DESIGN
DEVELOPMENT

3.2 EVOLUTION OF PROPOSALS / RESPONSE TO PRE-APP

Pre-application Reference No: 19/00186/PREAPP

Figure 20. Existing and Proposed Height and Massing Parameters Plan for 1st Pre-application

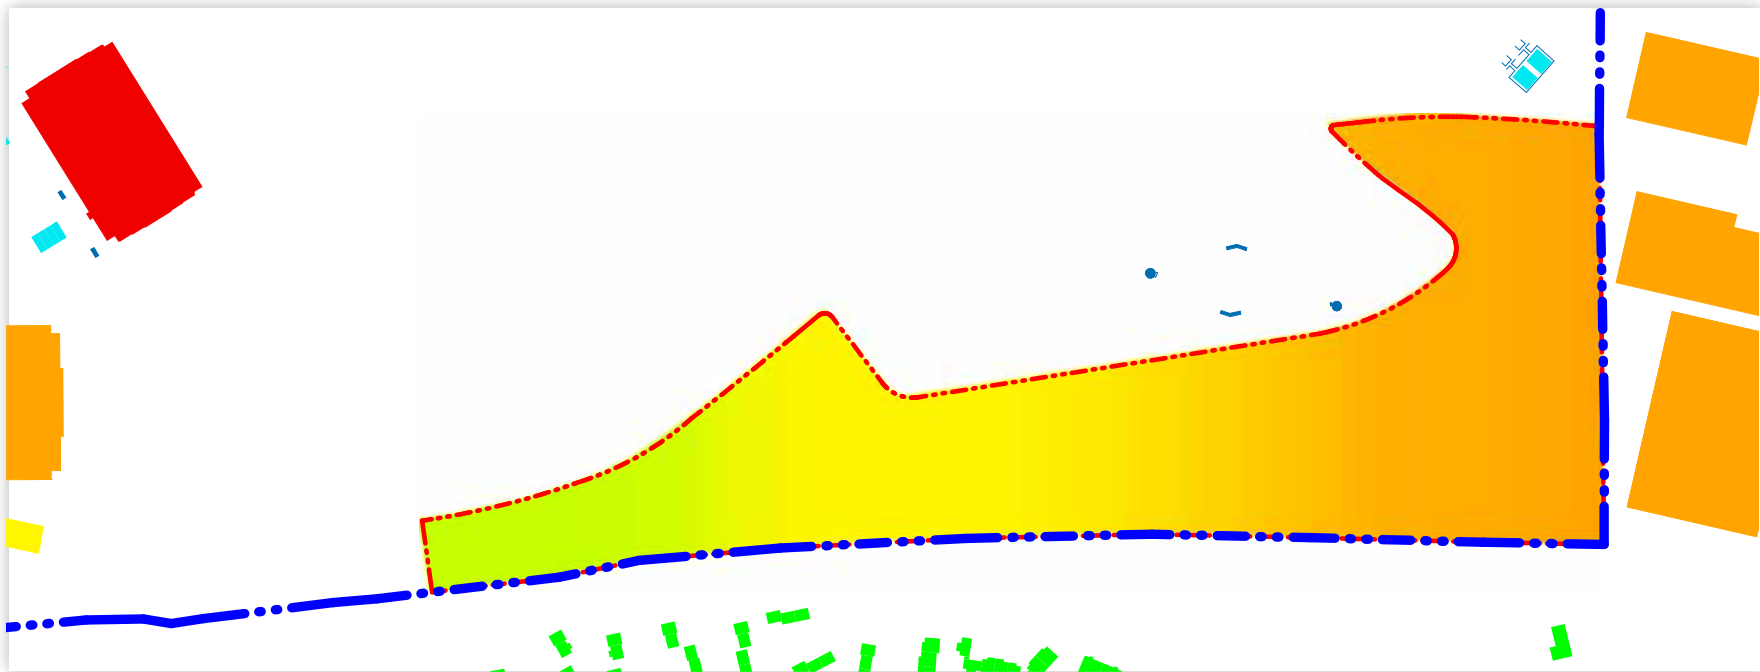
- Provide more refined Parameters Plans. It was also suggested that an Open Space / Landscaping Parameter Plan and a Scale & Massing Parameter Plan should be included.

- Provide some feedback on how photovoltaics could be used in the roof design.
- Concerns were raised about an unrestricted quantum and type of B8 use.
- Provide further detail and explanations concerning the proposed heights of the buildings (AOD).

- Provide clarification about the design, volumes and orientation of the building is needed.

Figure 23. Existing and Proposed Height and Massing Parameters Plan for 2nd Pre-application

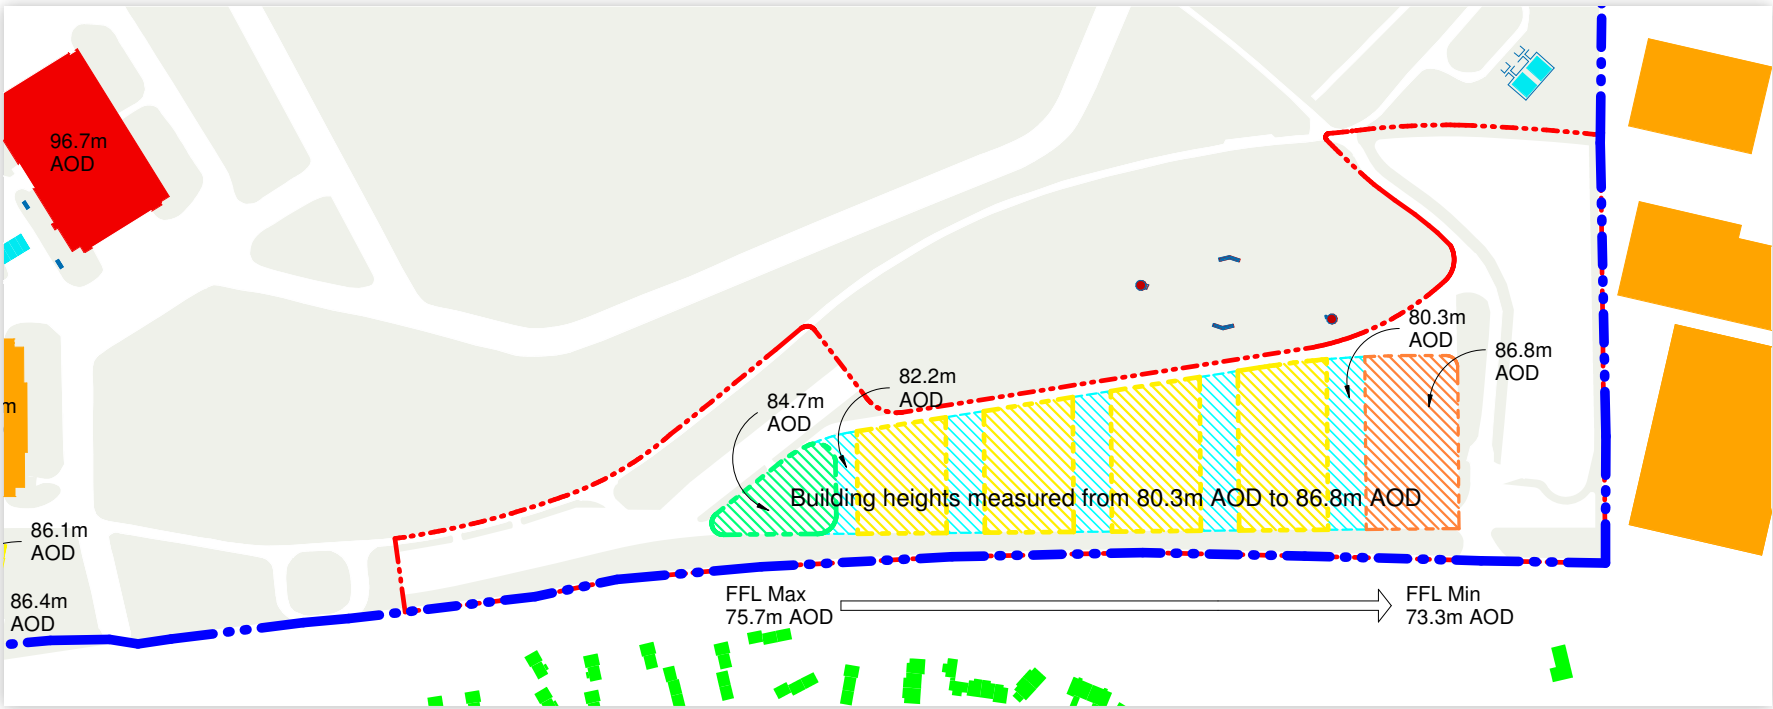
- It was advised that the then proposed height of unit 6 would not be acceptable and suggest that it was reduced from 86.8m AOD to under 85m AOD, bring it in line with the height of the adjacent industrial buildings.

- In response to the comment on the application site boundary, the application boundary line has been extended to the existing track to the north and the SAM included to firm up the relationship between the development and the SAM.
- The amount of B8 use was reduced.
- The height of unit 6 (86.8m AOD) was reduced to 84.8m AOD (11.5m above FFL)
- A Massing parameter has been added to the 'Existing and Proposed Height and Massing' Parameters Plan.
- An accompanied 'Design Code' has been established to provide more details on building frontages, roofscape, materials, colours etc.
- A series of site section sketches was completed in support of building heights, landscape strategies and the relationship between the flying field, the SAM and the F.A.S.T. development.

Figure 26. Mode Board for 2nd Pre-application

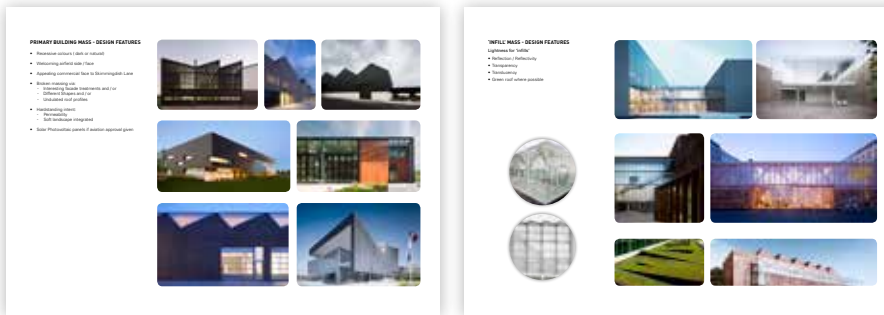
- A Design Code is required and needs to include information on building frontages, roofscape, materials, surfacing, landscaping etc.
- The Mood Boards were well received, with a few minor comments on some of the examples.
